DEVELOPMENT DETERMINATION PANEL MEETING

WEDNESDAY 24 MARCH 2021

Agenda for a Meeting of the Development Determination Panel to be held on Wednesday 24 March 2021

Figure 1. Annotated section plan of the proposed development demonstrating the extent of the height breach (beyond 8.5m) in red.

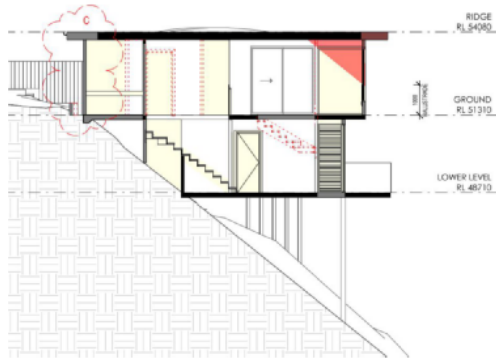
Description of non-compliance:

Development standard:	Height of buildings
Requirement:	8.5m
Proposed:	10.88m
Percentage variation to requirement:	28% (2.38m)

Fig 1: Section extract to indicate area of dwelling roof exceeding the 8.5m height control

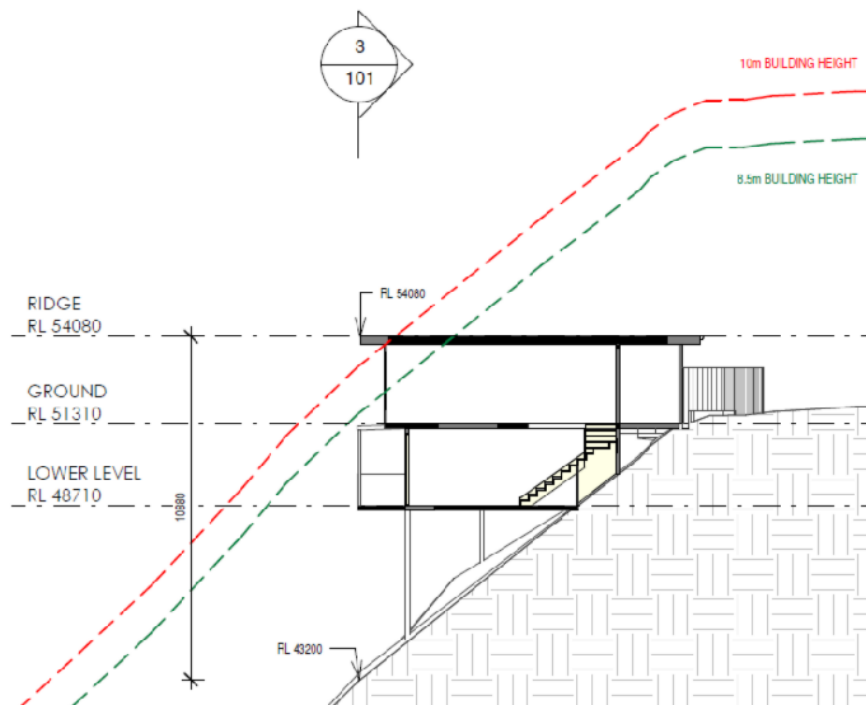
The proposed additions and alterations to the existing dwelling, which as a result of the significant slope of the site will provide a height of up to 10.880m above natural ground level and which exceeds Council's maximum building height by 2.38m or 28%. The proposal therefore does not comply with Council's maximum height control. The extent of the building's roof which exceeds the 8.5 height control is detailed in Figure 1 (over page).

Figure 1 - nomination of points tha

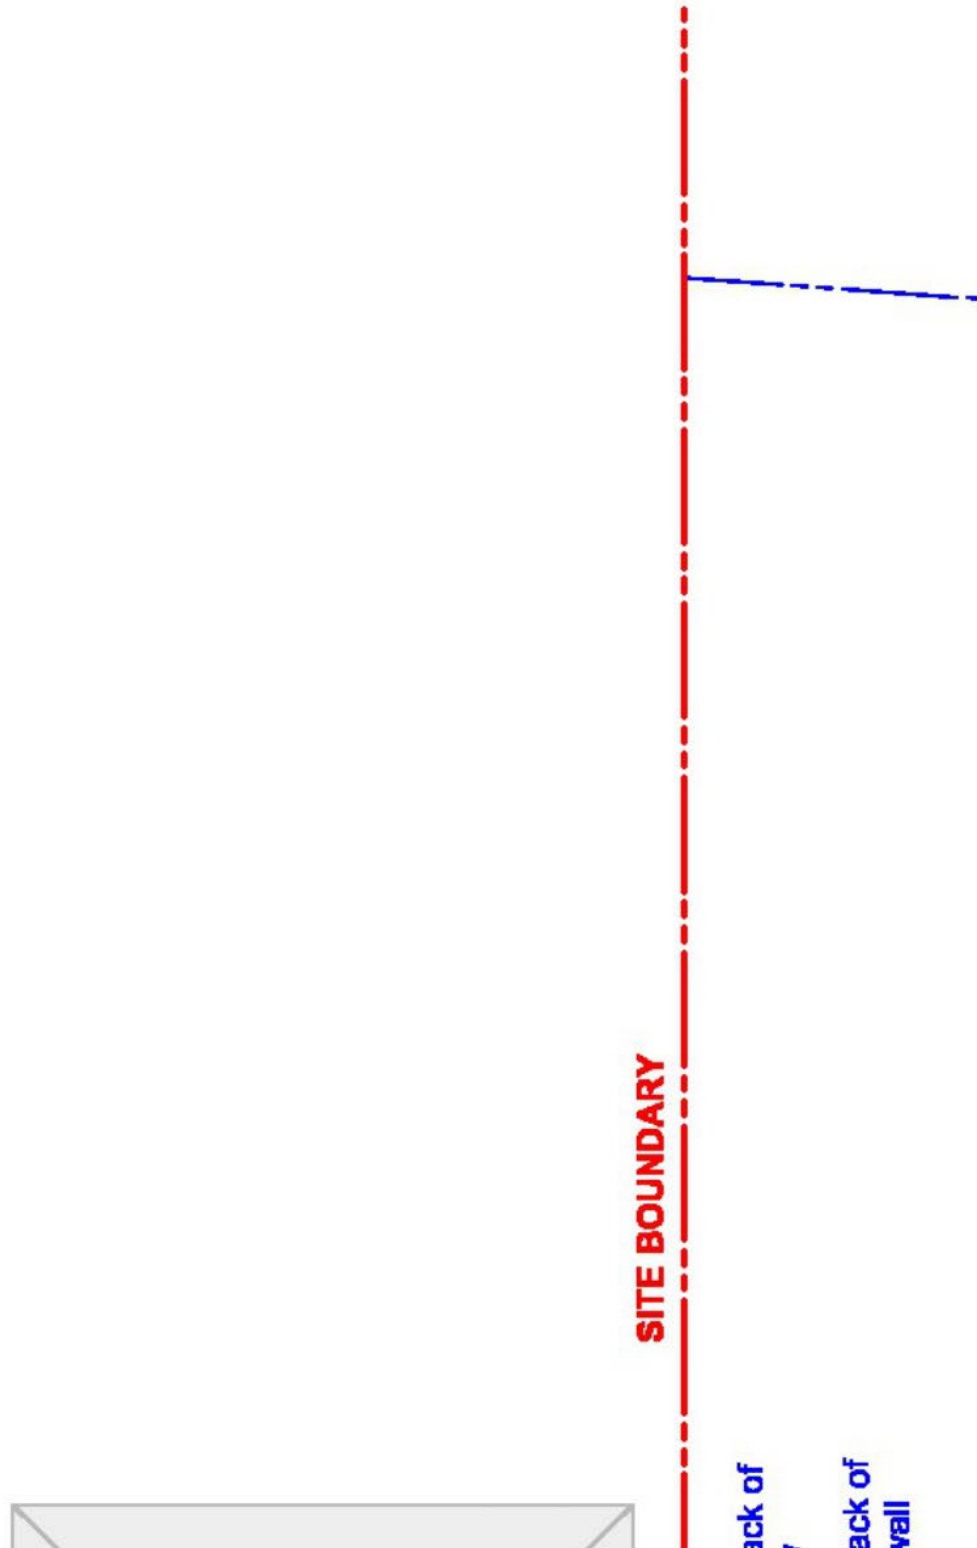
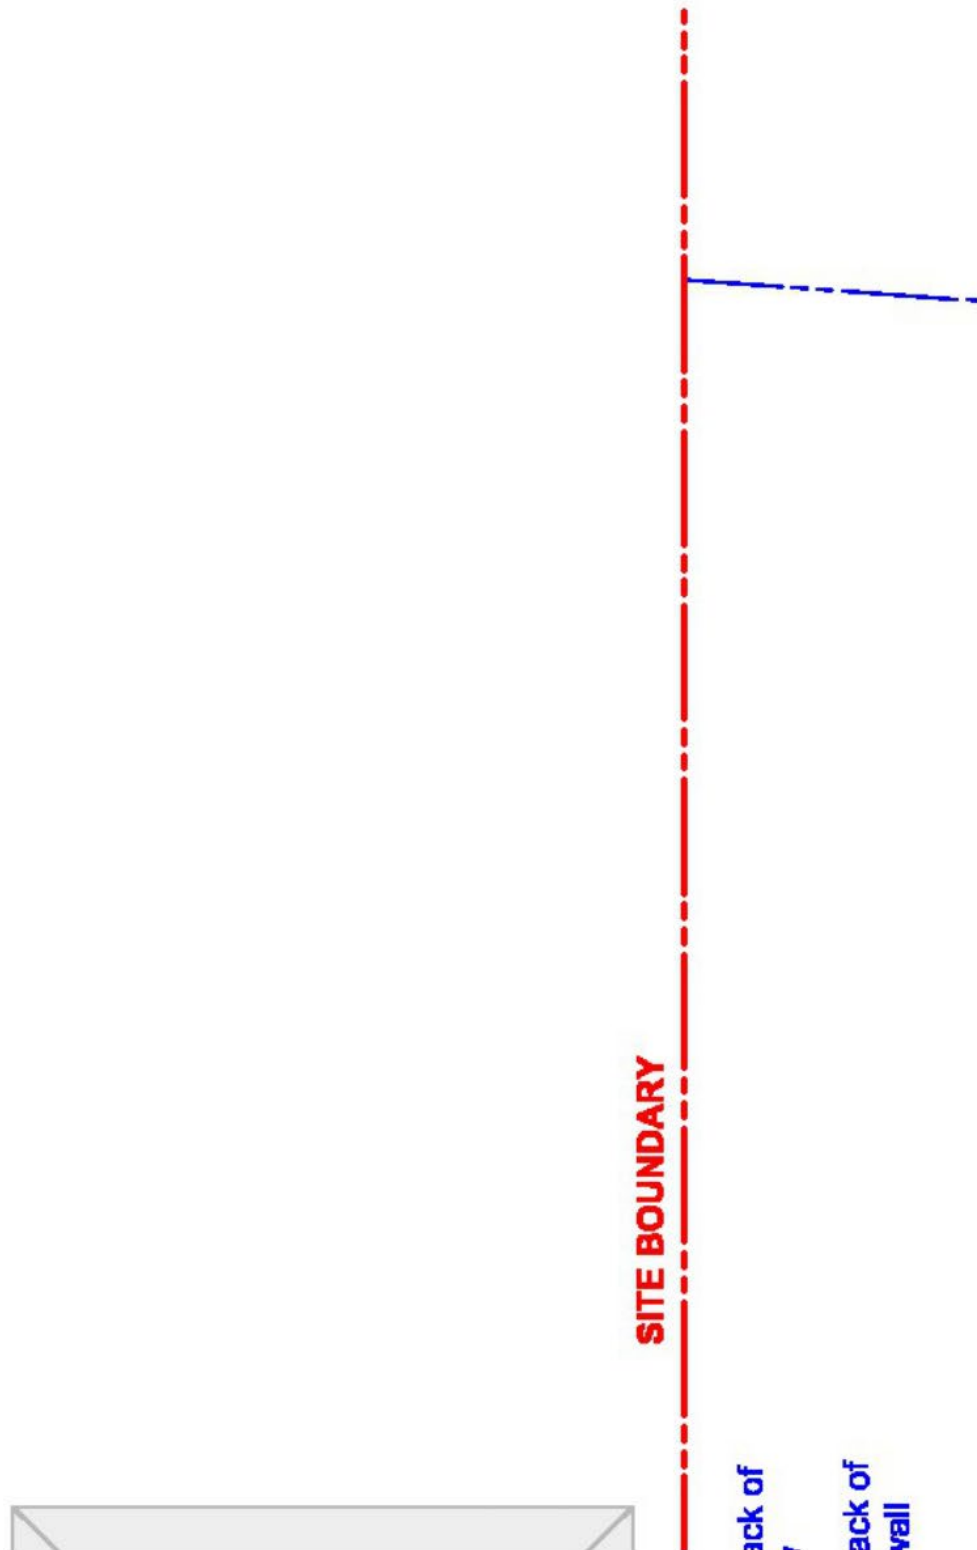
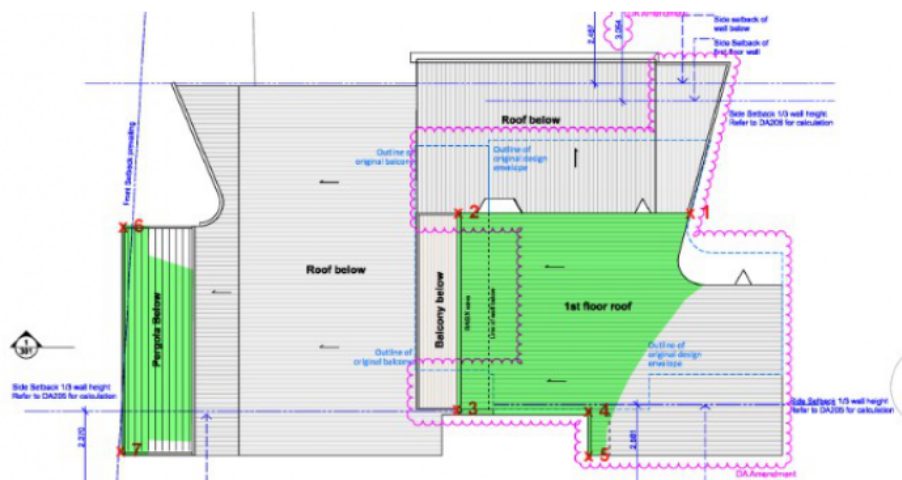
The areas of height non-compliance determined by the assessing officer, in relation to the points shown on **Figure 1**, can be identified as follows:

7. The north-western corner of the pergola roof over the ground floor front balcony reaches a height of 8.92m. The assessing officer relies upon nominated spot levels on the survey below the proposed roof (RL32.74 (roof) - RL 28.82 (ground) = 8.92m).

Figure 1 – Plan extract showing height non-compliance based on interpolated ground level (existing)

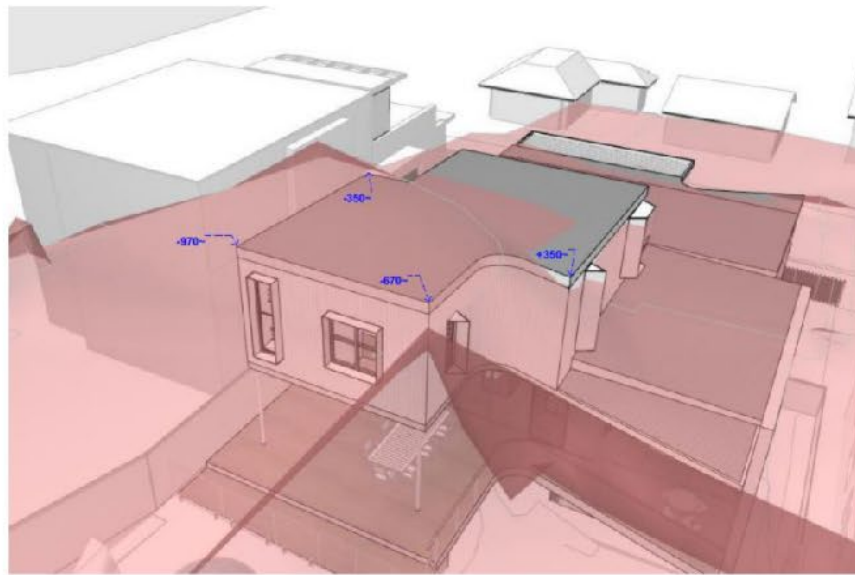
This diagram shows the northern edge of the street facing upper ground level pergola and northern portion of the first floor addition breaching the 8.5 metre height standard with the breaching elements depicted in grey. This diagram, together with the dimensions contained on the elevation plans, depict a height breach to the street facing upper level pergola of approximately 300mm (3.5%) and a maximum height breach in the north eastern corner of the proposed first floor roof form of 874mm (10.28%).

Figure 3 – North elevation with building height breaching elements (as determined from surveyed spot levels) shown in red

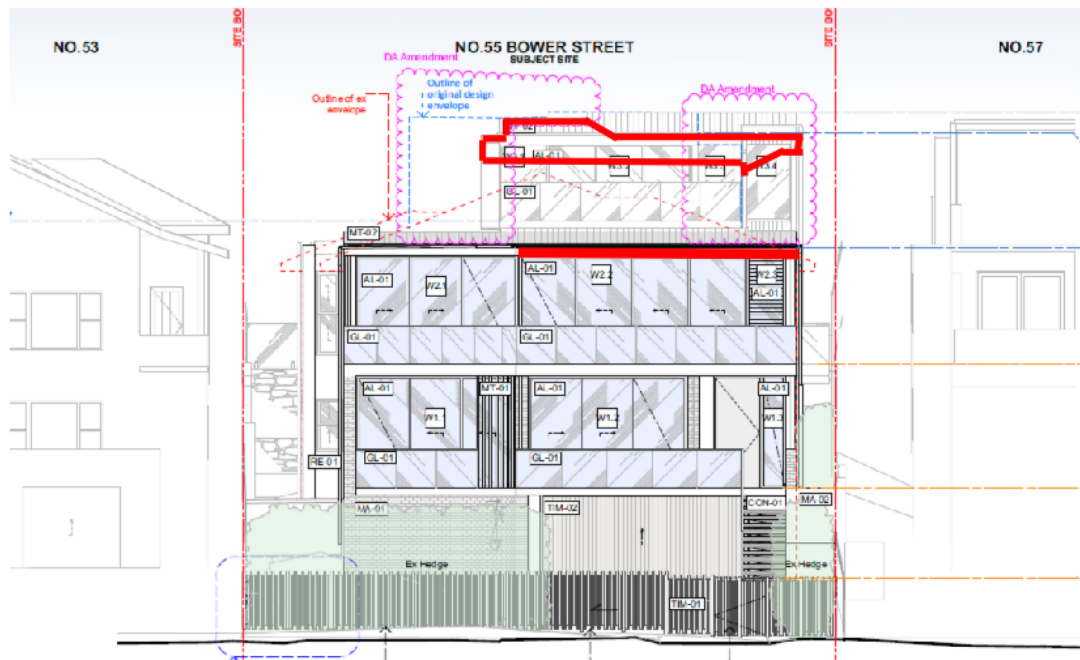
The following diagrams and table show the proposed building heights having regard to the spot levels contained on the survey plan below the nominated corners of the roof.

Figure 4 – Western elevation with building height breaching elements (as determined from surveyed spot levels) shown in red

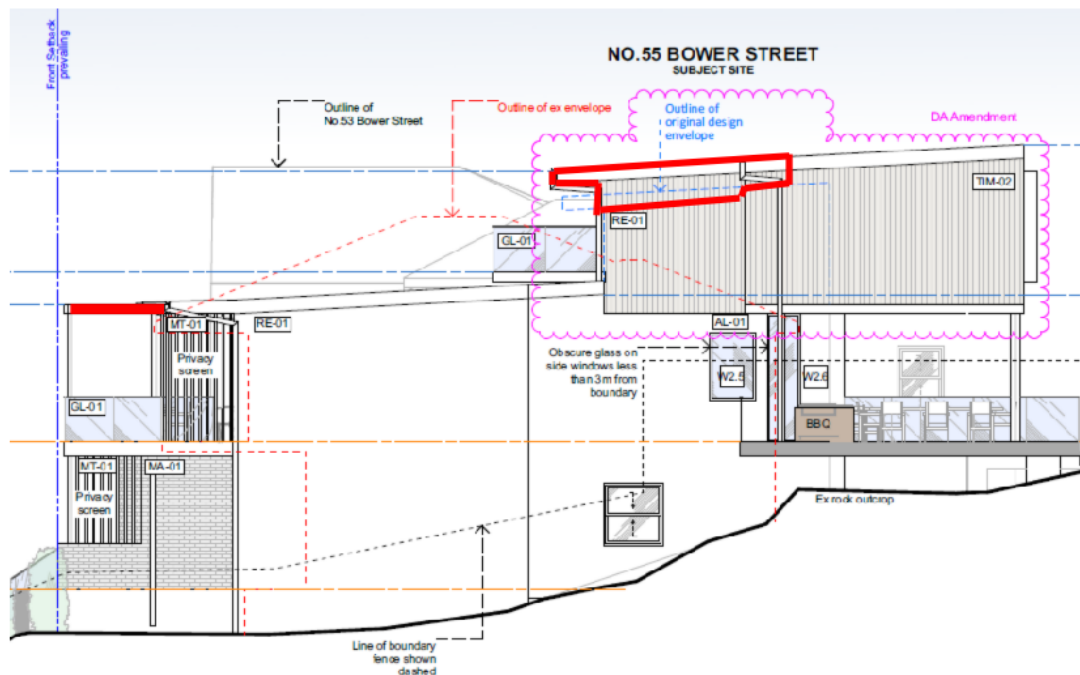
The proposed building heights when measured at roof locations 1 – 10 on Figure 2 are summarised as follows:

B3 Side Boundary Envelope

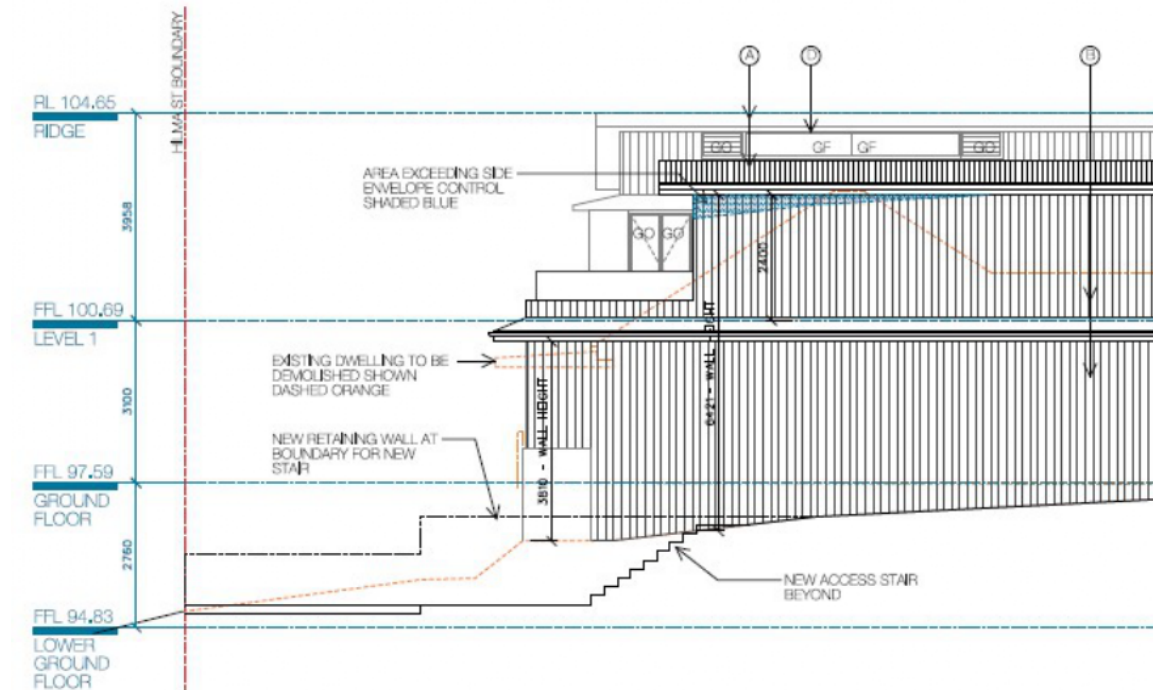
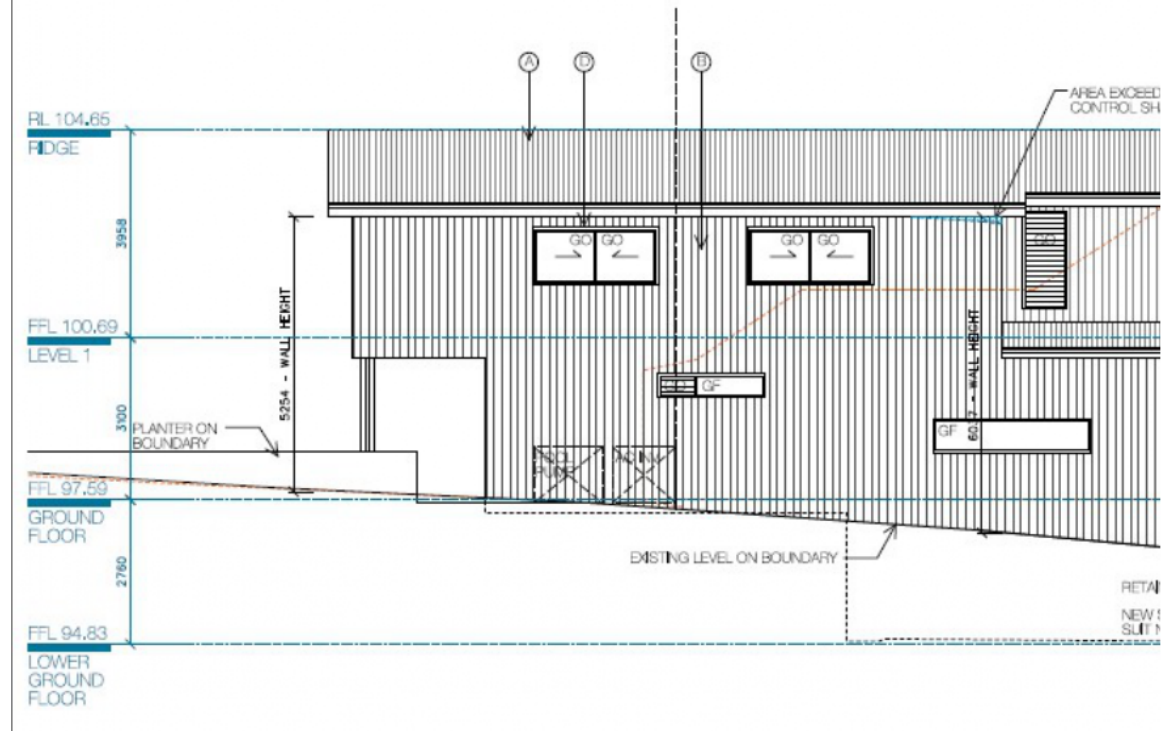
Description of non-compliance

With regard to the consideration for a variation, the development is considered against the underlying Objectives of the Control as follows:

Having regard to the above assessment, it is concluded that the proposed development is consistent with the relevant objectives of WDCP 2011 and the objectives specified in s1.3 of the Environmental Planning and Assessment Act, 1979. Accordingly, this assessment finds that the proposal is supported, in this particular circumstance.
